November 6, 1984  
IPN-84-53

Subject: Indian Point 3 Nuclear Power Plant  
Docket No. 50-286  
Indian Point 3 Midcycle Steam Generator Inspection

RESPONSE TO NRC QUESTIONS FROM MEETING OF NOVEMBER 2, 1984

Figure 2 Rev 1

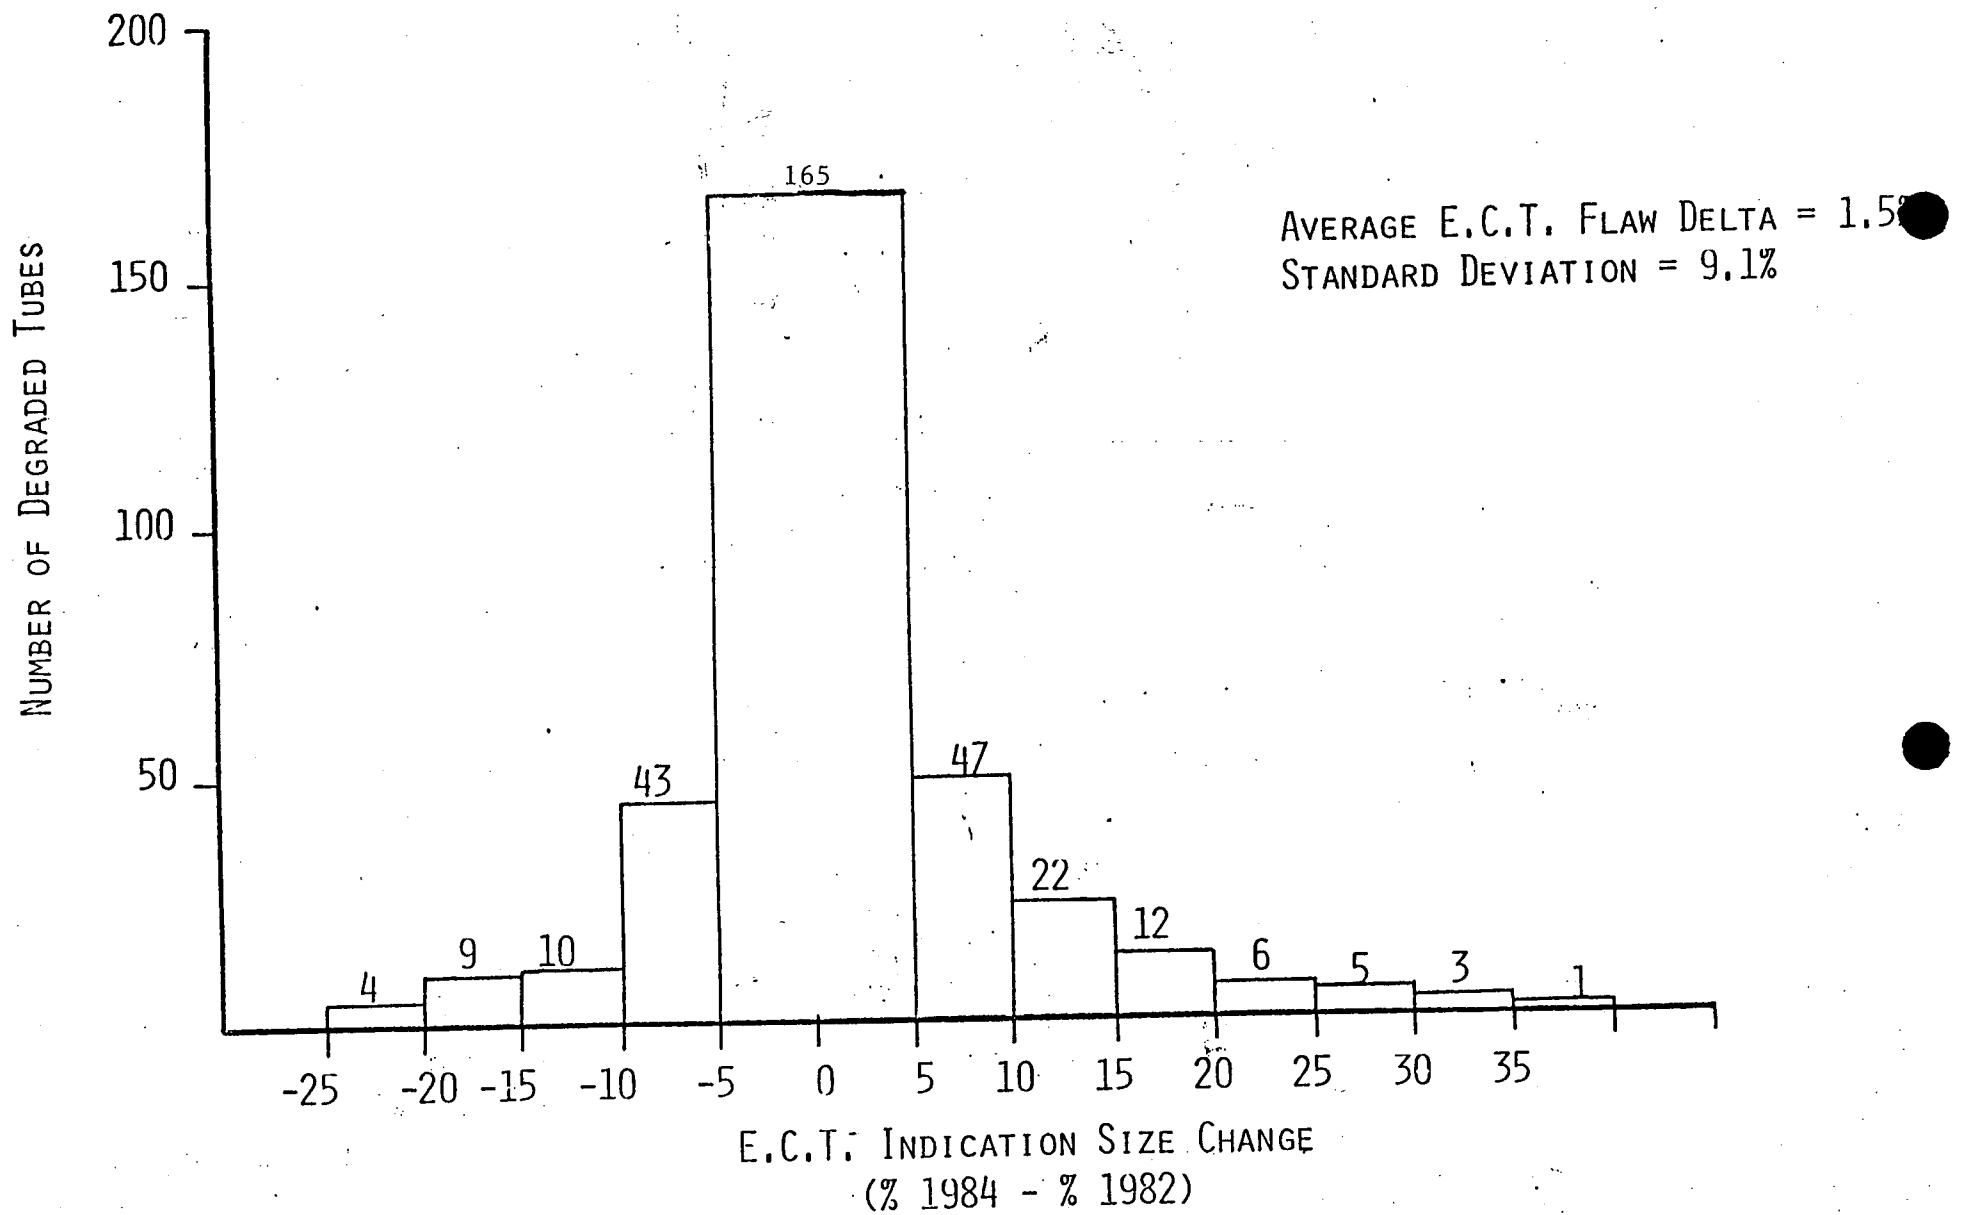
Attached please find information the NRC staff requested at the November 2, 1984 meeting held in Bethesda, Maryland concerning the Indian Point 3 midcycle steam generator inspection. In addition, a revised Figure 2, submitted to the NRC in Attachment II of Application for Amendment to the Operating License, dated November 1, 1984 (IPN-84-52), is also provided herein.
